OBJECTION TO: MIRVAC PROPOSAL – HARBOURSIDE SHOPPING CENTRE DARLING HARBOUR

Figure 1: illustration of extended Guardian Square

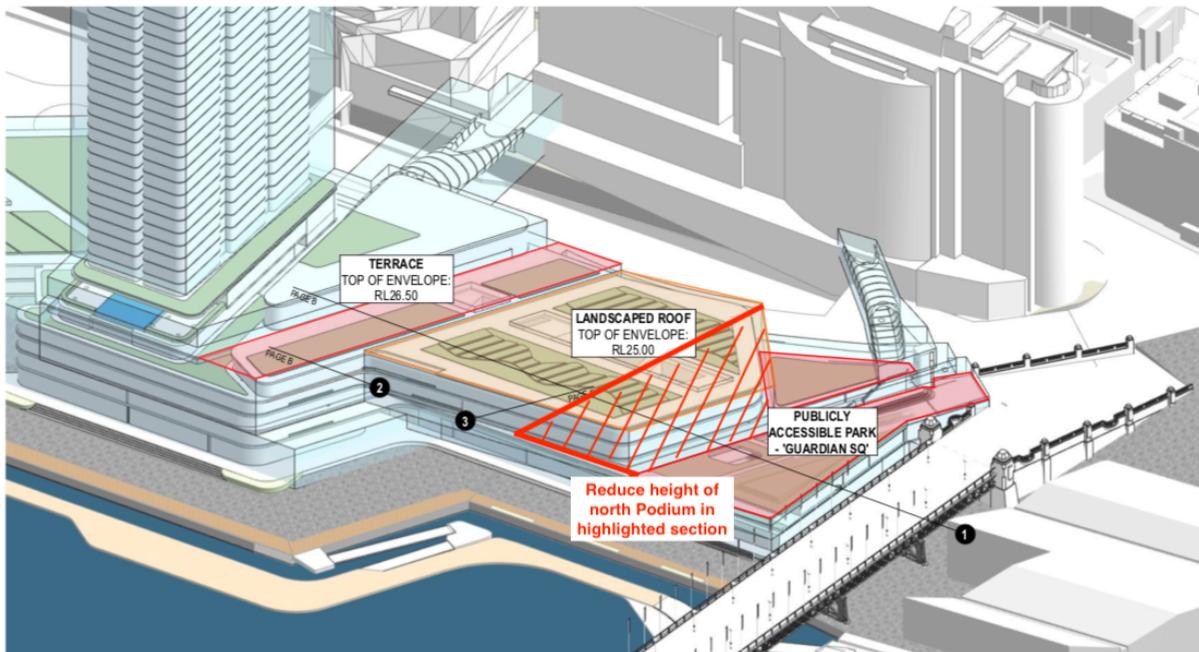
The current height of the northern Podium poses problems of overshadowing Darling Harbour and its iconic Pyrmont Bridge, as well as affecting the views of residents of Murray Street. The recommendation is to extend the Guardian Square, at **RL12**, to a width of 65 metres (away from the bridge), before the height increase of the northern Podium, to only **RL19** (see figure 1 and 2). This would create an inviting looking garden space when viewed from the bridge and vice-versa.

The Northern end of the PODIUM should be no more than two storeys high or **RL12** (in keeping with the bridge height and also same as Cockle Bay side, adjacent to Bridge) and extend at this height (RL12), at least 65 metres away from the Bridge.

Figure 3: Remove dilapidated monorail and lift structure

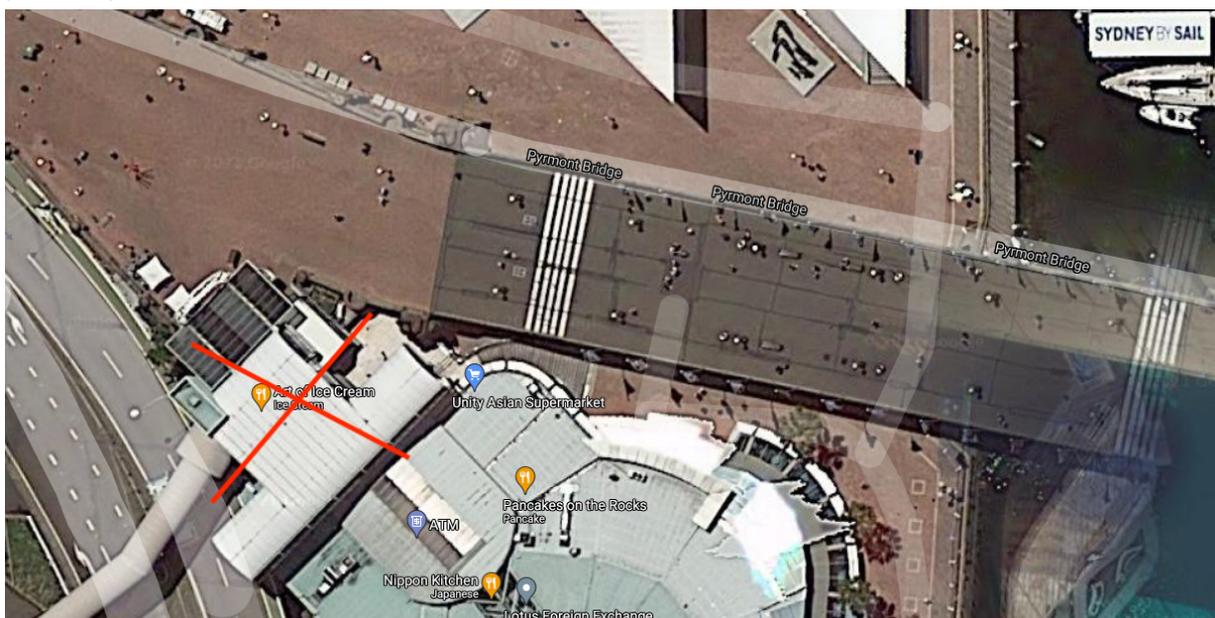
These structures are all old and redundant (as seen in photographs 1 & 2) – they must be **removed, and nothing rebuilt in its place**. Their current existence shows how bad it is to have anything of height and bulk adjacent and overshadowing the historic Pyrmont Bridge. The old station is tall and impinges on the Pyrmont Bridge due to its height and proximity.

The lift block should also be removed (see figure 3 and 4). It is very old and with the implementation of recommendation 3 (page 4), the use of this lift becomes redundant. A new and better lift (or escalator) should be incorporated into the design, within the taller section of the north Podium (excluding the Guardian Square) to serve citizens coming from Murray Street area. Furthermore, this derelict station should not be used as a benchmark to justify heights for new structures!

Figure 5: Suggested new footbridge

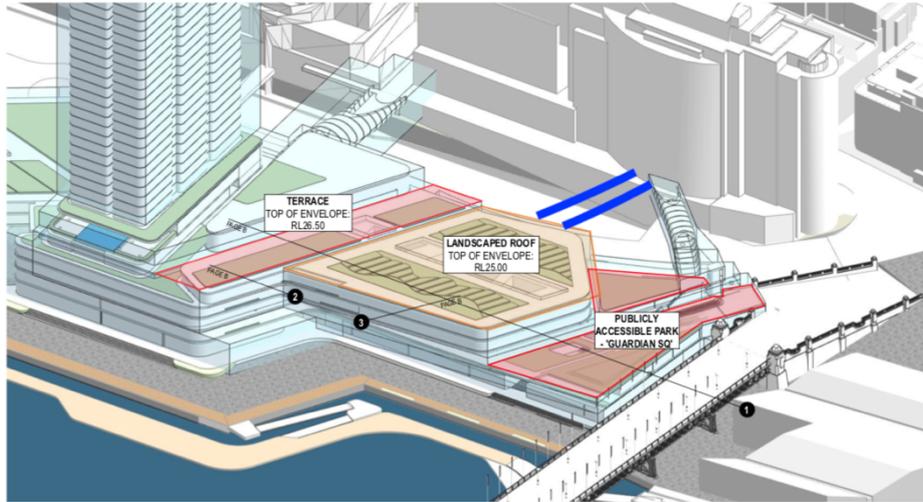
The foot bridge access from Murray Street foreshore walkway should be redesigned and flow straight into the shopping area (see figure 5 & 6). Its original configuration to the North (Monorail stop) is now defunct. Its new purpose should be to link directly to the shops and restaurants – a good undercover entry will bring a flow of business from Murray Street directly into the mall. Additionally, it will be better than having an unsecured entrance from Guardian Square to the footbridge.

A more practical footbridge, to link Murray Street directly into the shopping centre, should be incorporated into the design.

Figure 7: devastating loss of views for residents

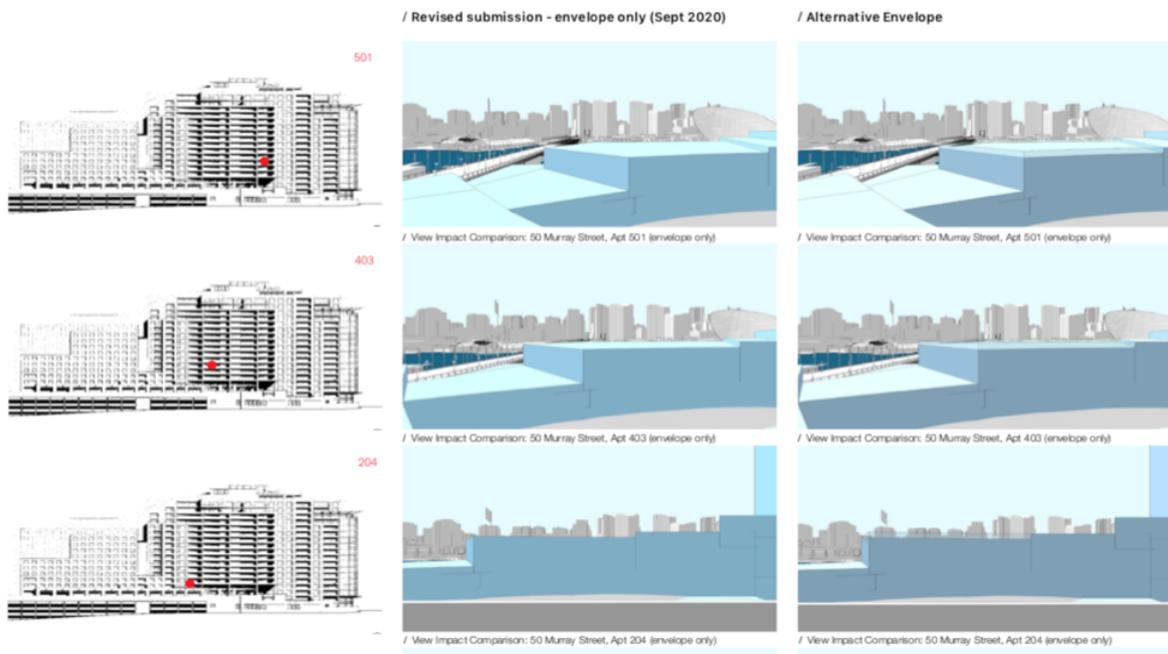
The height of the northern Podium removes direct water views for many residents of 50 Murray Street. As seen in figure 7, the proposed Podium height will cause devastating impacts on their properties and leave them to look at block-like backside of a shopping centre. This impact will be felt all the way to the 8th floor (there are only 16 floors of residences).
